No. 88-16

Possible Water Leak Caused by TR/TRS Transom Cutout

Figure 1.

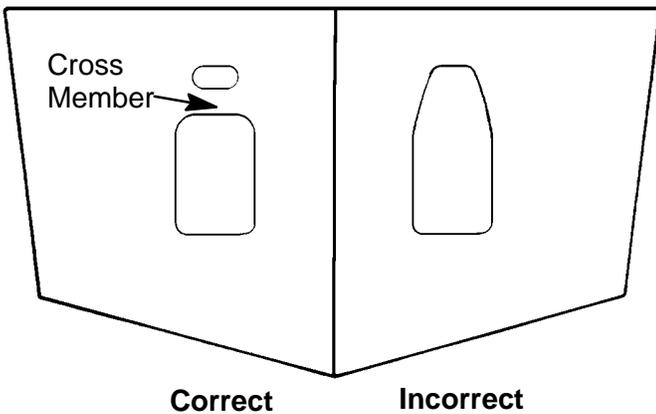
It has been brought to our attention that some boat manufacturers have been incorrectly cutting the transom cutout for the TR/TRS model stern drives.

The current style gimbal housing (shown in Figure 2) is now cast with a hole for access to the "U" bolt nuts at the top of the gimbal ring. Keep this in mind when replacing the gimbal housing. The cross member between the upper and lower cutout opening (shown in Figure 1 following) is required to support the cork gasket to prevent water from leaking into the boat.

a - Water Leakage Problem
Current Style
